Before Independent Hearings Commissioners

Applications for resource consents, and a Notice of Requirement for a Designation by Wellington Water Limited on behalf of Upper Hutt City Council, for the construction, operation and maintenance of the structural flood mitigation works identified as the Pinehaven Stream Improvements Project

Statement of Evidence of Alexander Keith Ross

Dated 27 July 2020

Photograph of secondary flow path caused by undersized culvert and vegetation blocking the channel below the culvert at 122 Pinehaven Road.

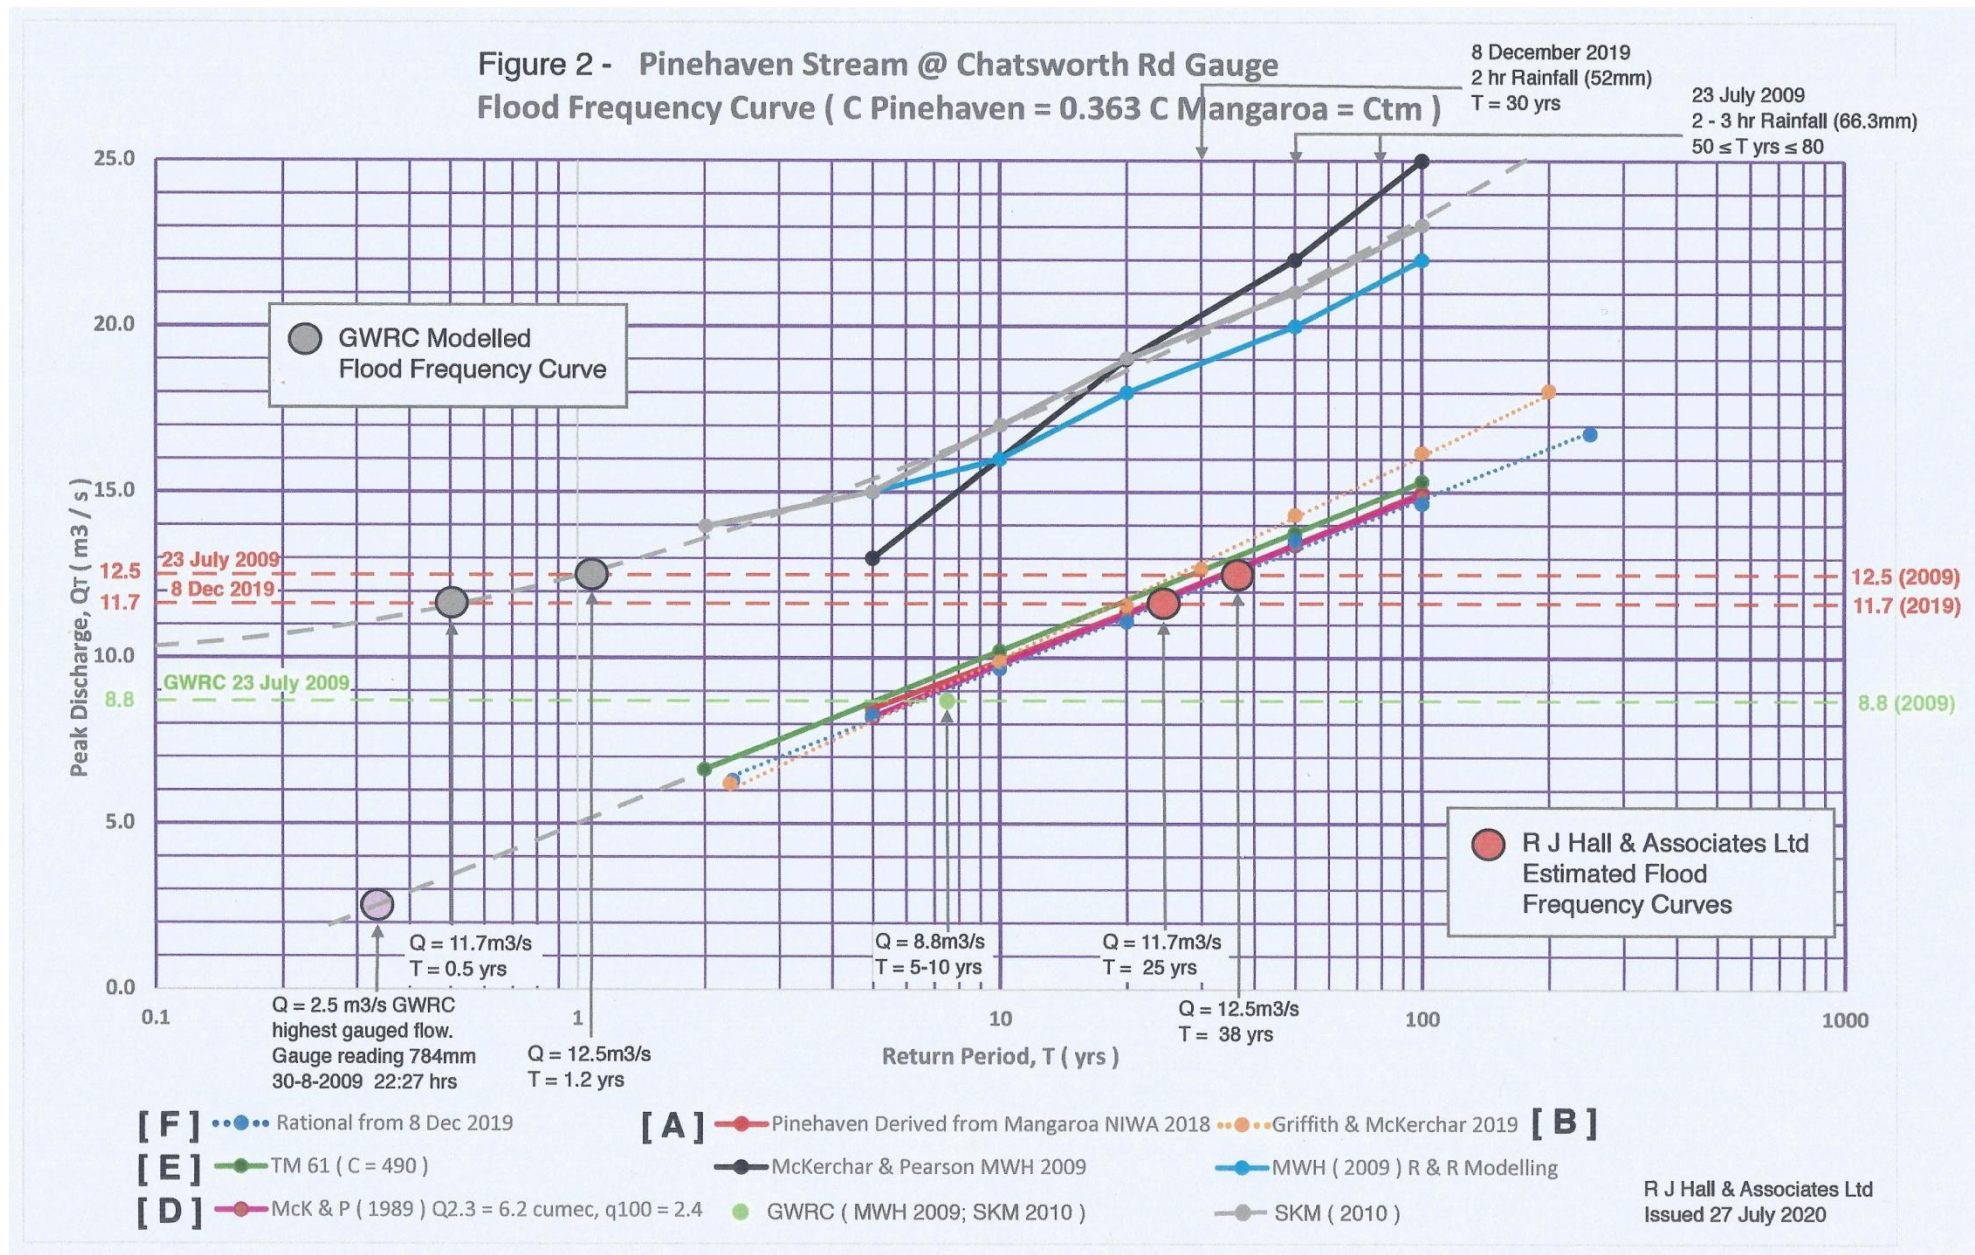
5.2 However, the residents now find out that no works are proposed in the upper catchment where there are several problems that need addressing. This despite the cost ballooning out from \$10M to now over \$40M when interest on loans is factored in. (See photograph attached).

Rating Curve from RJ Hall showing Peak Discharge vs Return Period and Highlighting the error in GWRC flood estimates.

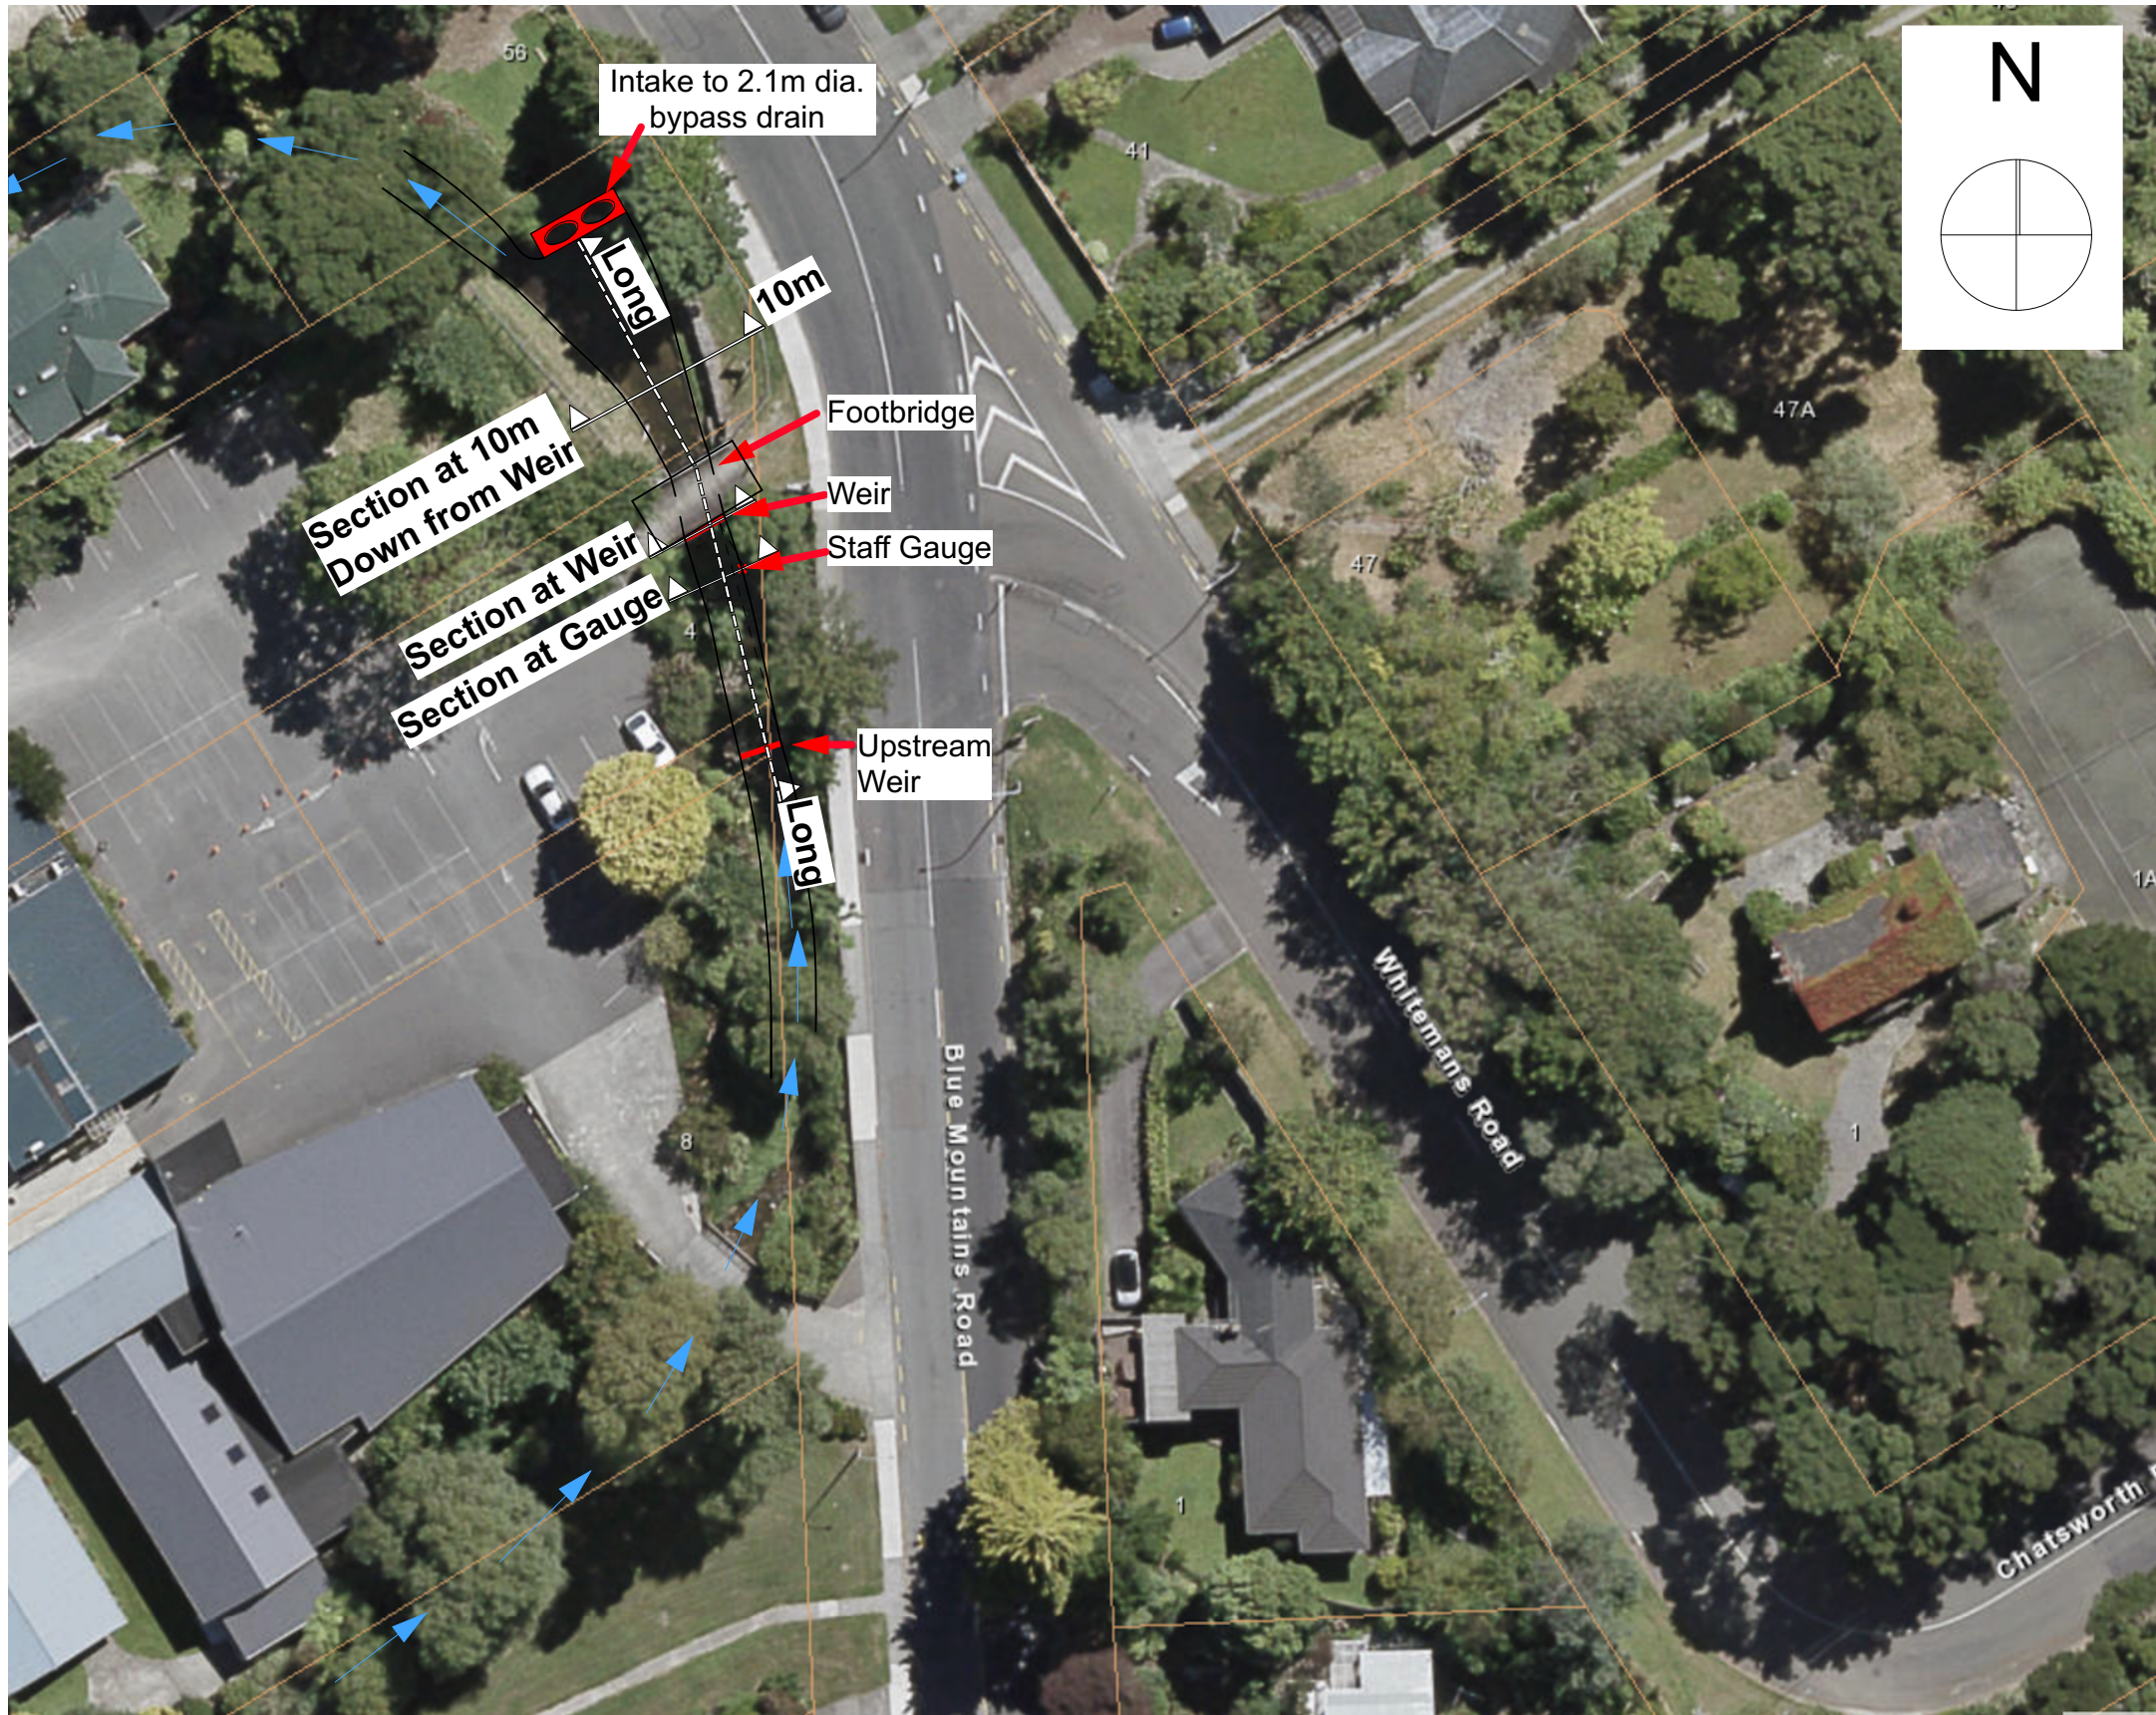
8.9 The attached graph ex R Hall shows how the peak flows have been exaggerated in the model as even the GWRC 8.8 m³/sec peak flow does not fit their own rating curve but does fit the rating curve calculated by the submitters.

Figure 1: Flow gaugings available and the problem with extending the rating curve without high flow gaugings.

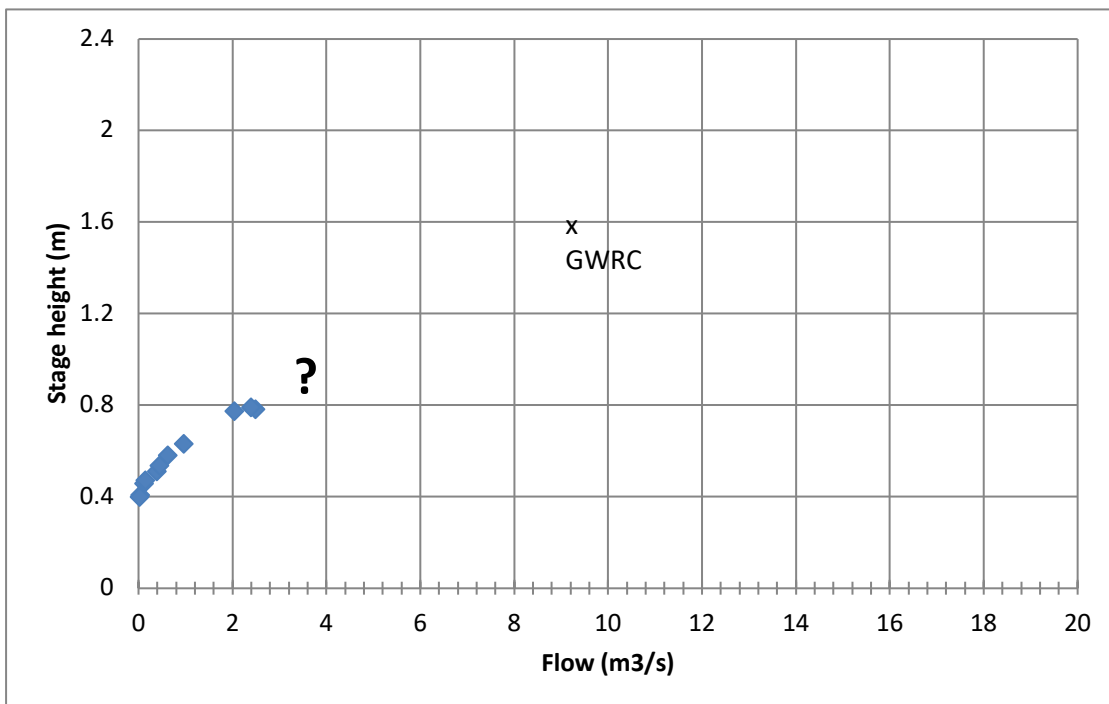
The problem for the GWRC hydrology team was how to extend the rating curve from 0.8 m to 1.6 m Figure 1, due to the lack of high flow measurements. The lack of any flood measurements or mapped flood marks during the peak of the 23 July 2009 is disappointing as the capture of flood measurements for flood design purposes is the main reason for the flow recorder site on Pinehaven Stream opposite Chatsworth Road.

High flow gaugings will give key information for extending the rating curve to provide accurate values of the peak flood. Unfortunately one gauging was completed the day after on 24th July but the flows had receded considerably to only 0.44 m³/s. An attempt was made on 30 August 2009 to measure high flows to define the top end of the rating however stage height levels measured were less than 0.8 m, some 0.77 m less than the 1.577m peak measured on 23 July 2009 peak.

Figure 4: Pinehaven Stream at Chatsworth road stage height versus mean velocity curve

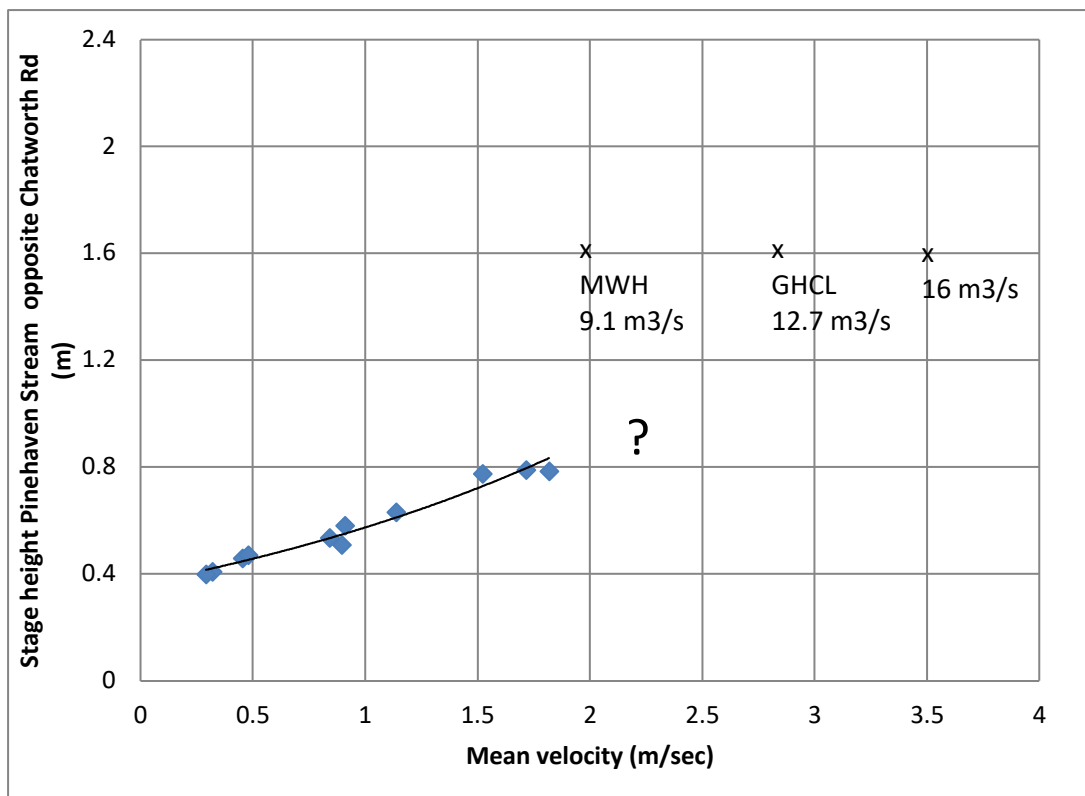
Figure 4 displays the problem with extending the stage/velocity curve between 0.8 m and 1.6 m. The MWH approach was to adopt 2 m/sec at stage 1.6 m. However this is only a 10 % increase in mean velocity from the stage of 0.8 m. This is not plausible in such a smooth bedded and smooth walled channel. My estimate is 2.8 m/sec which would result in a 12.7 m³/sec flow at 1.6 m, however for a flow of 16 m³/s a mean velocity of 3.51 m/sec would be required.

My estimate of the flow peak at 1.577 m on 23 July 2009 is 12 m³/s, however future high stage gaugings to define the stage/mean velocity curve would provide higher confidence to estimates. I consider the 8.8 m³/s an underestimate. Interestingly the SKM (2010) reported modelling of 23 July 2009 event shows a peak discharge of approximately 11.8 m³/s, but unfortunately their depth at the staff gauge is 400 mm less than measured, this detracts from the use of this single calibration.
